SAFETY NOTICE: SNUG harness

This safety notice applies to SNUG harnesses manufactured in February 2017, which use plastic wire to retain the rescue.

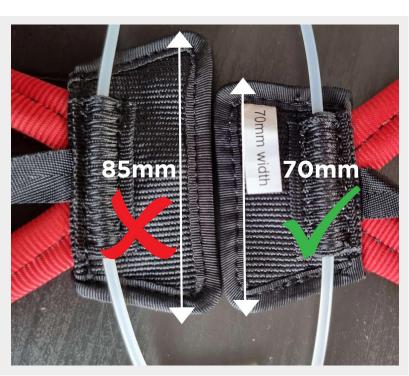
On some SNUG harnesses a pull force greater than 10kg is required because the black webbing of the rescue handle is too wide. It should not be wider than 70mm (see photo). If your harness has a plastic wire type reserve closure, please check this. If the rescue handle webbing is wider than 70mm please contact us and we will send you a replacement rescue handle free of charge.

OK: Reserve handles with stainless steel pins are unaffected

Reserve handles which use plastic wire to retain the rescue should be checked.

Send an email to <u>office@flybgd.com</u> stating the serial number, date of purchase and the dealer or shop that sold you the harness. Please include an address to send the replacement handle to.
